# PLAN OF PROPOSED IMPROVEMENT

## ACACIA RIDGE PHASE 10

CITY PROJECT NO. 14833  
CONTRACT NO. 9340

Revision 2: 05/28/2024  
Sheet U-2: Changed pipe size P-1  
Sheet U-STM: Revised pipes P-1 and P-2,  
revised structures S-1 and S-2

DATE	BY	14833	L-1
REVISION	DATE	14833	L-1
DESIGNED BY: ##	DATE: 5/15/2024 6:29 AM	14833	L-1
SCALE: #####

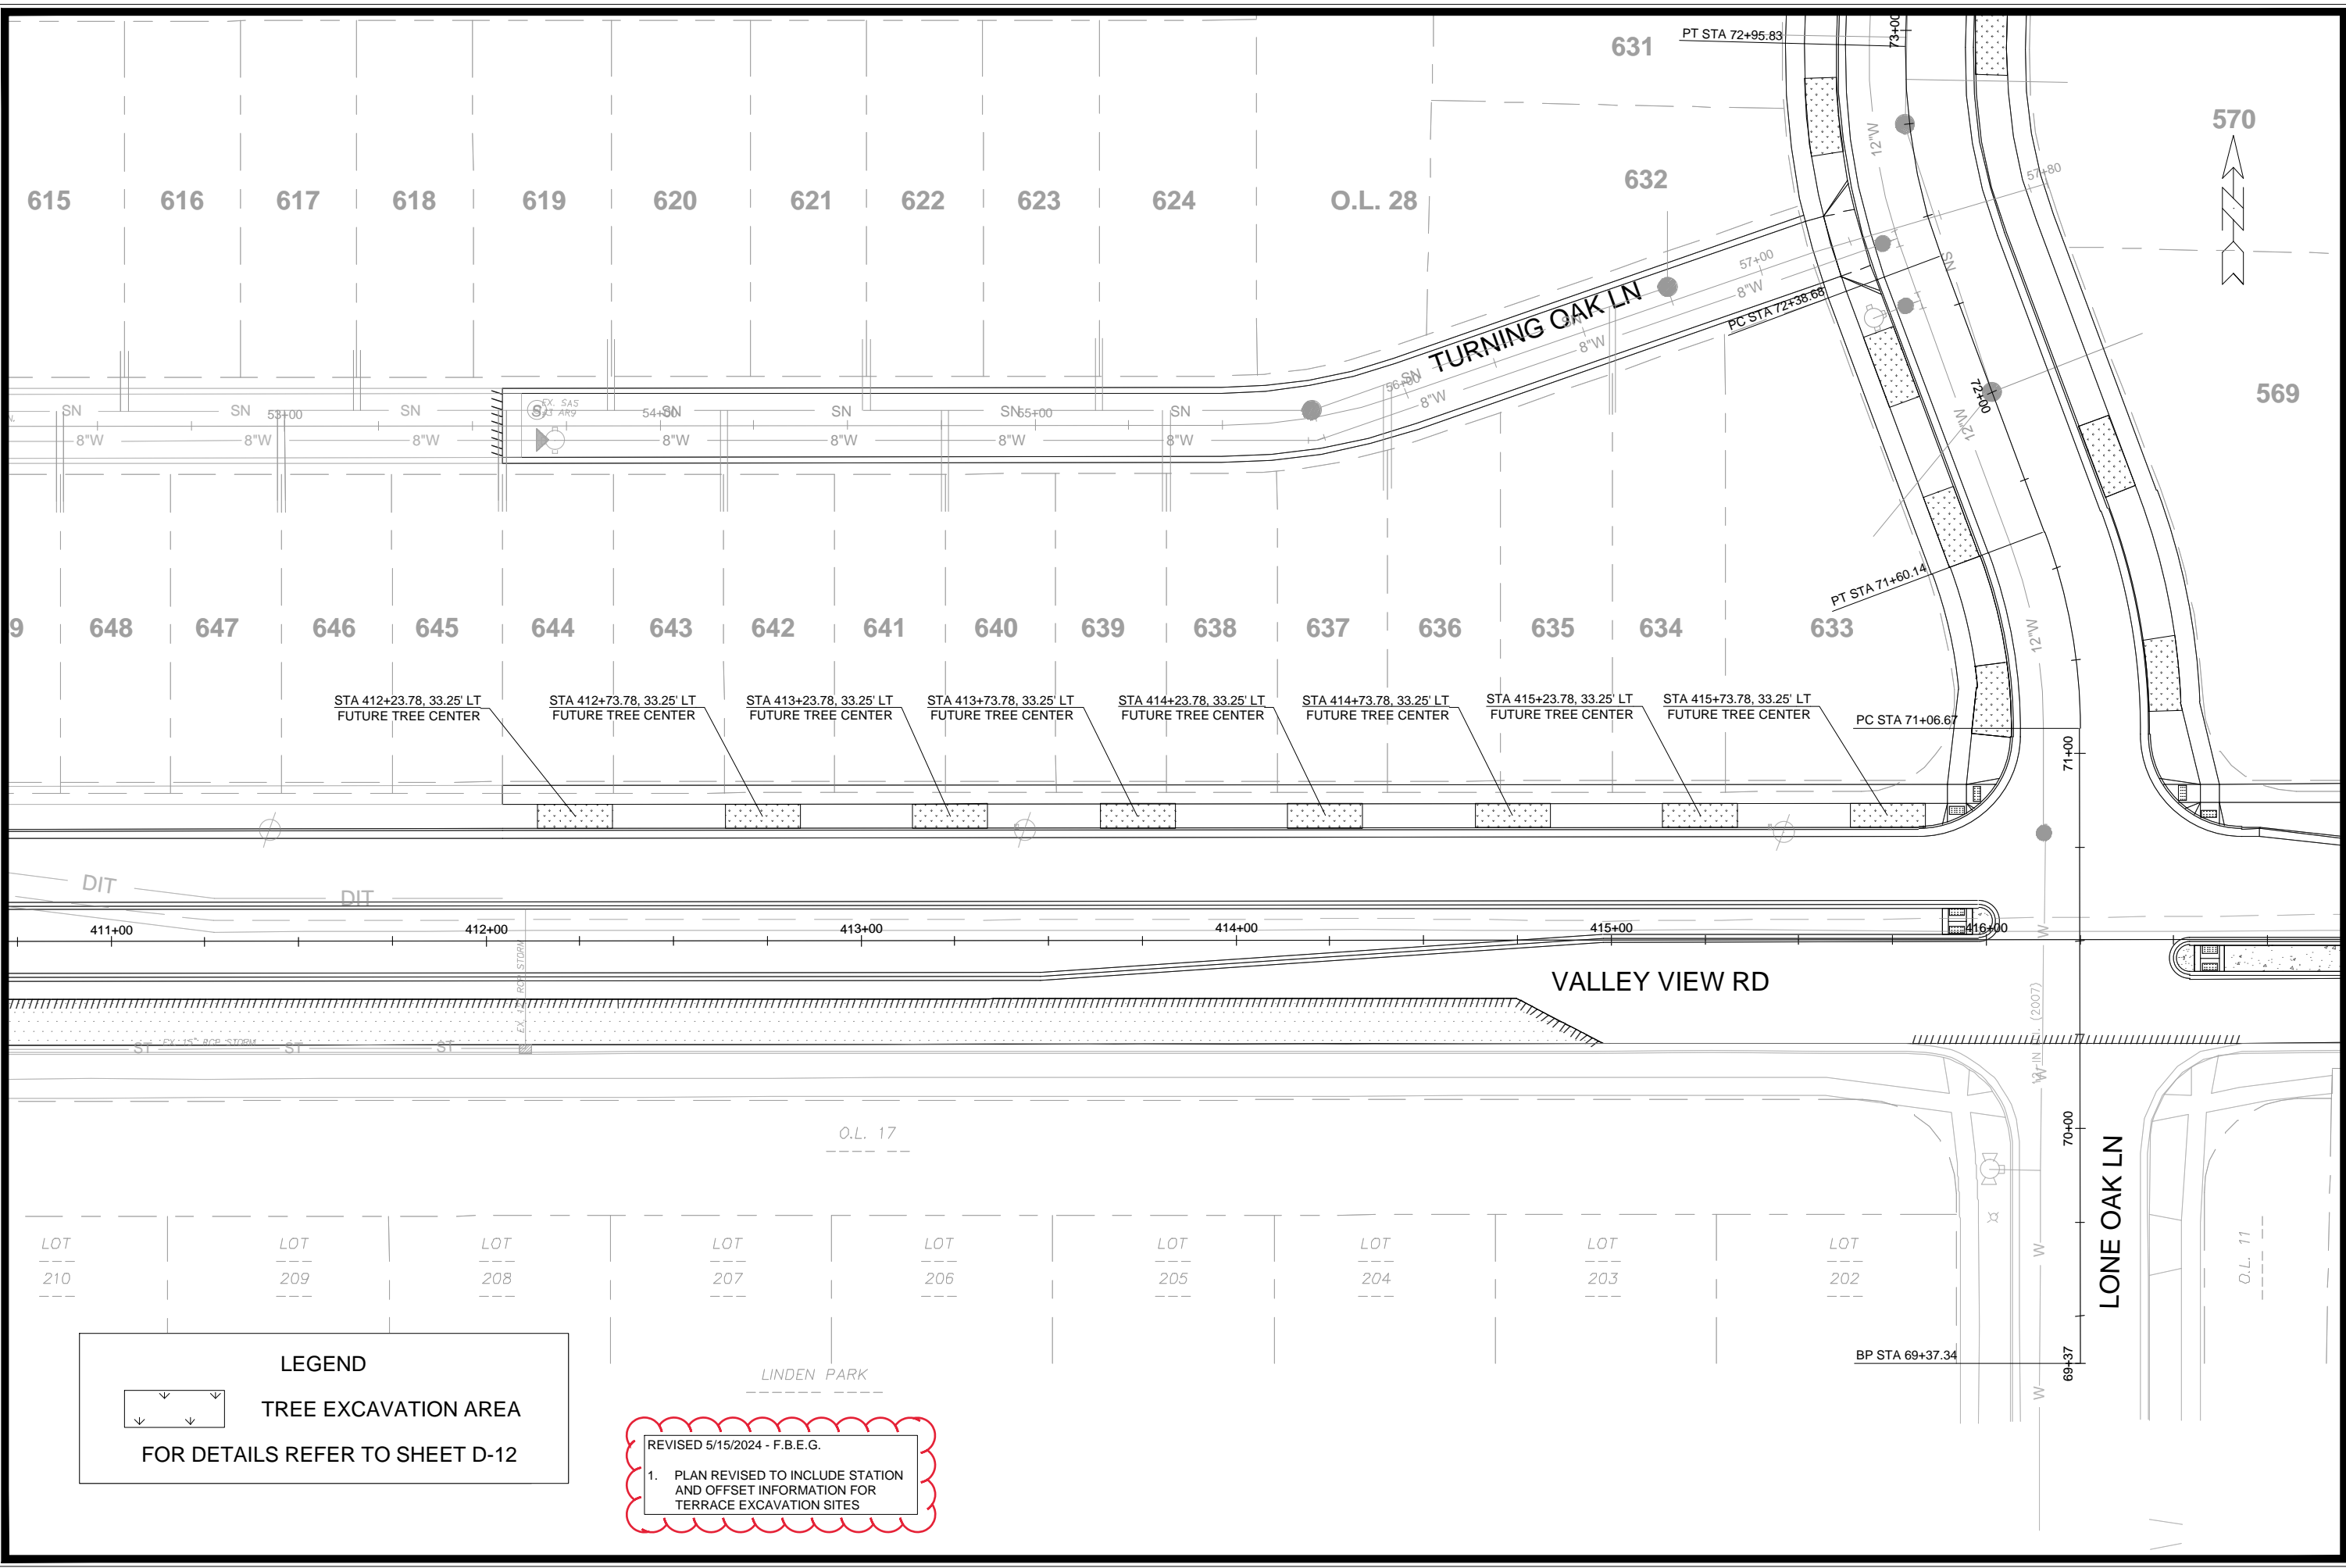
REVISED 5/15/2024 - F.B.E.G.  
 1. PLAN REVISED TO INCLUDE STATION AND OFFSET INFORMATION FOR TERRACE EXCAVATION SITES

LANDSCAPING PLAN - HONEY HARVEST LN  
ACACIA RIDGE PHASE 10  
M:\DESIGN\Projects\14833\CAD\Sites\14833EN-TreeExcavationSites.dwg

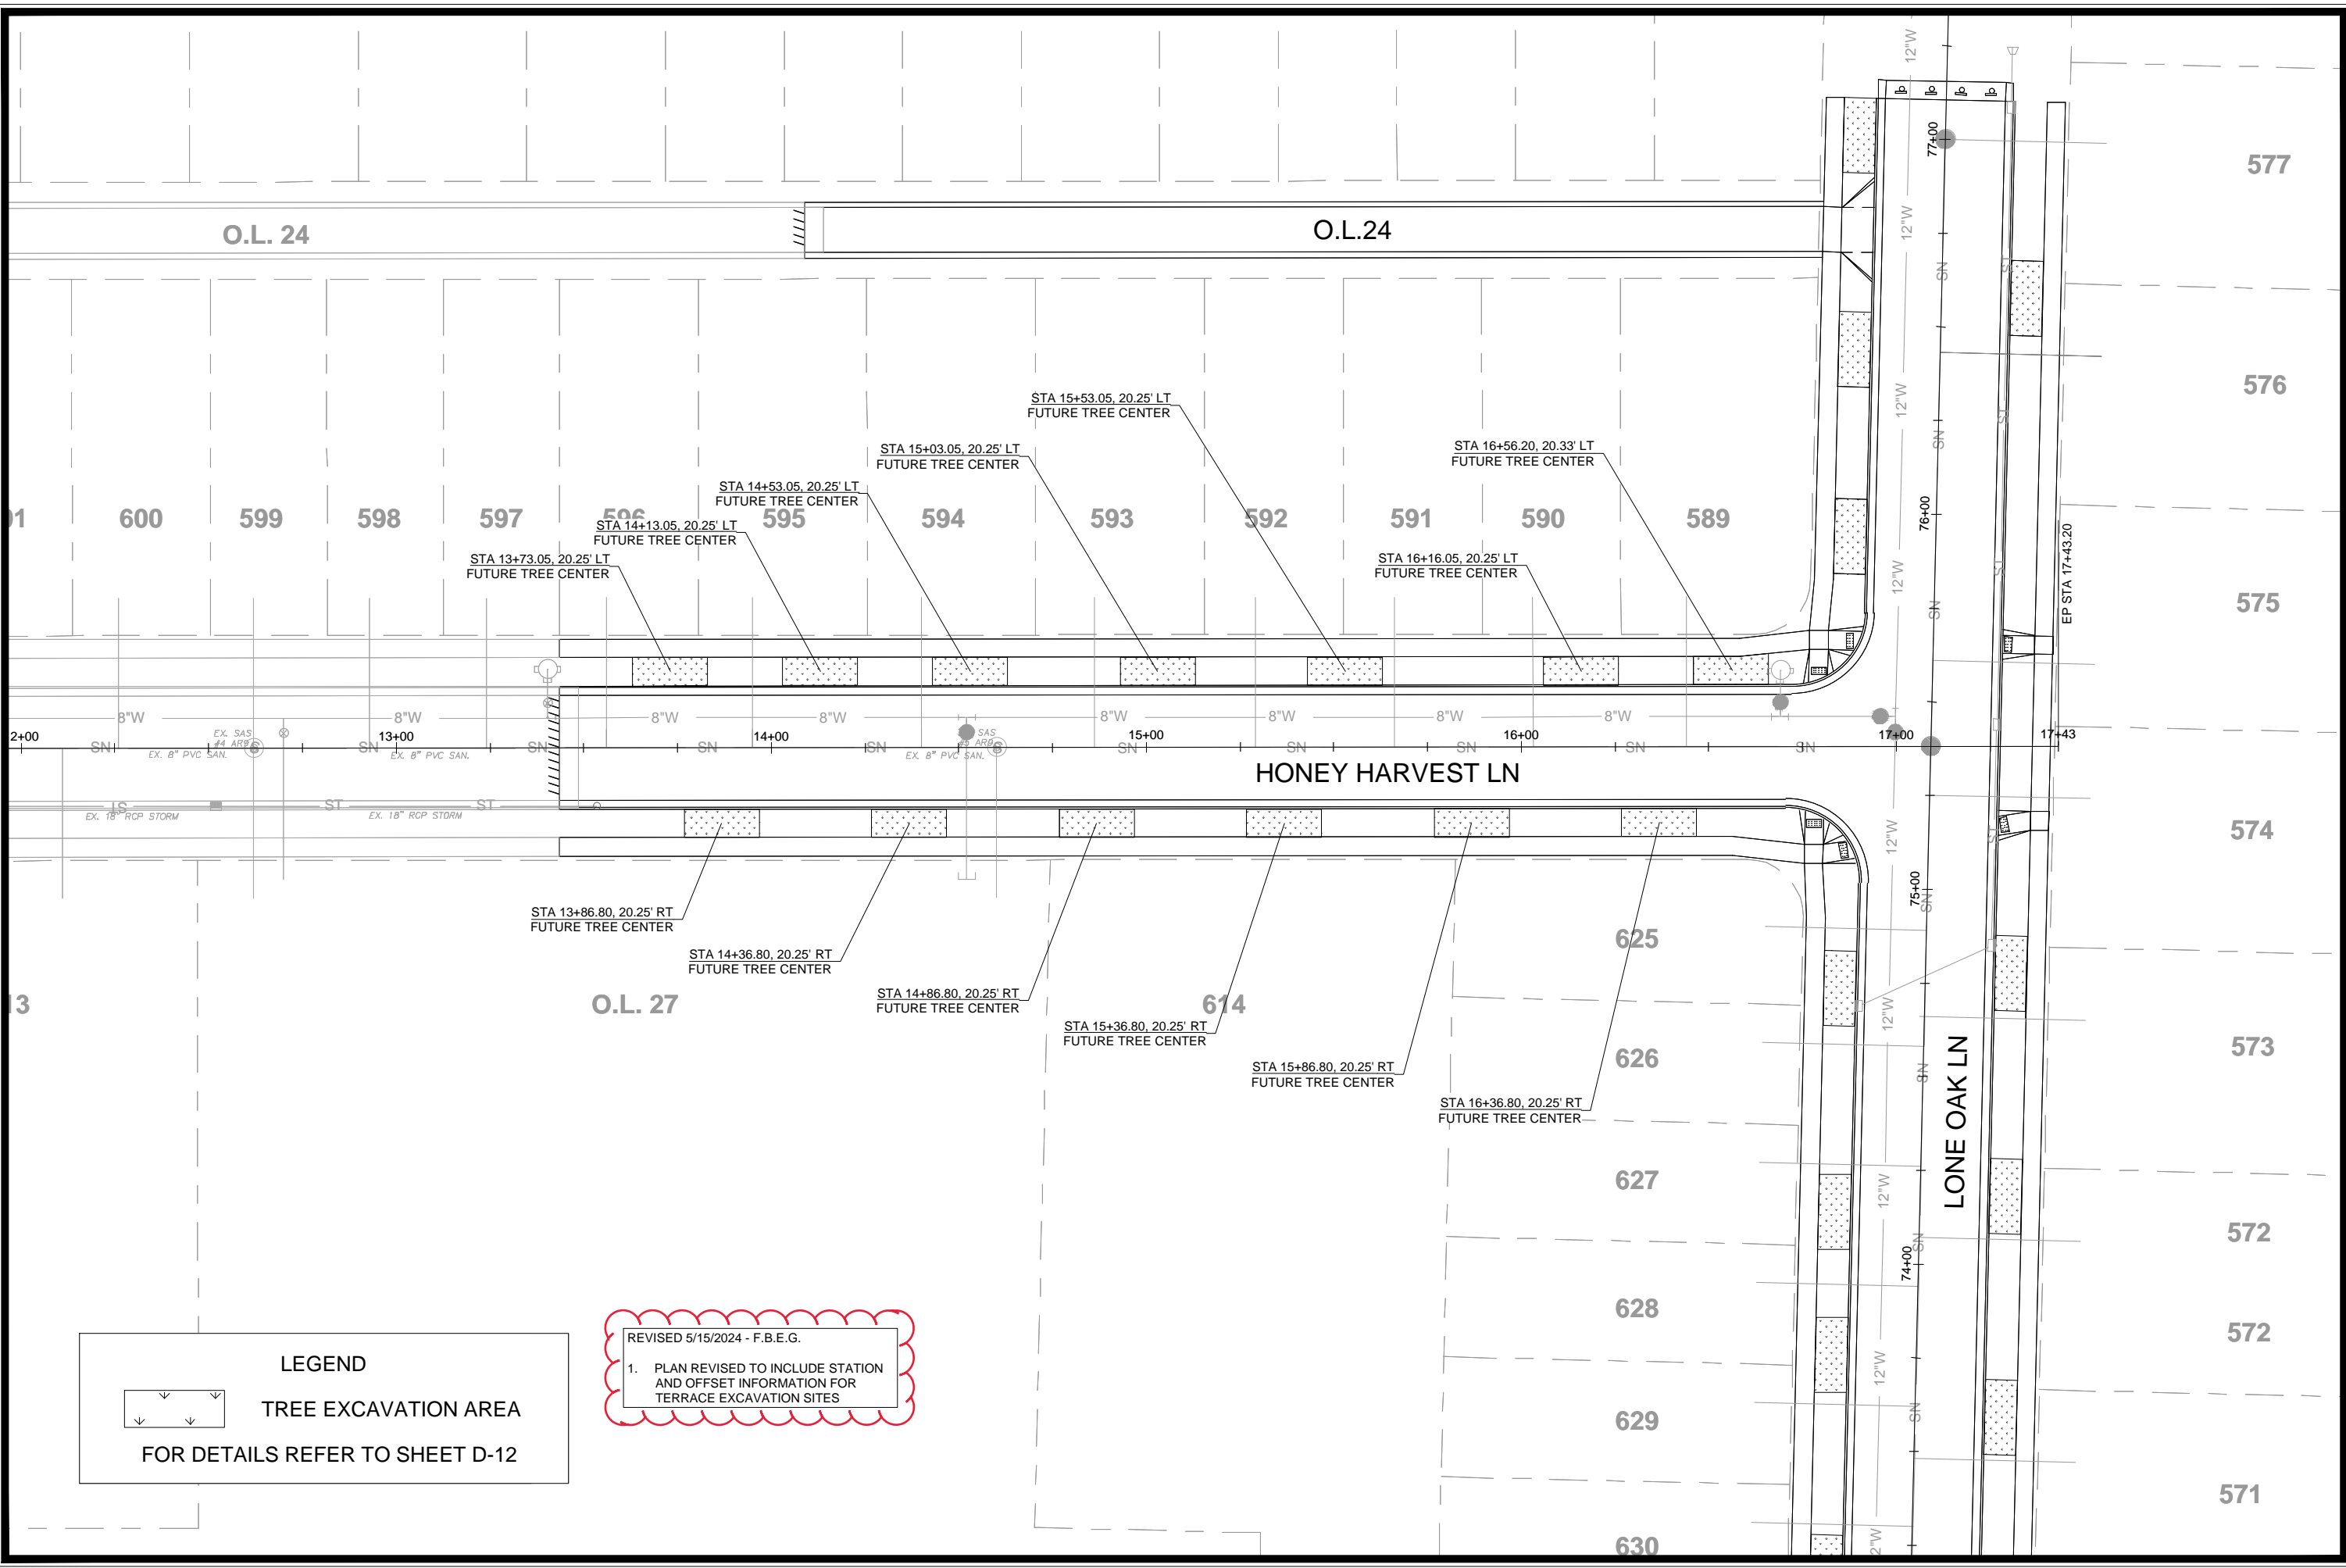
1. PLAN REVISED TO INCLUDE STATION AND OFFSET INFORMATION FOR TERRACE EXCAVATION SITES
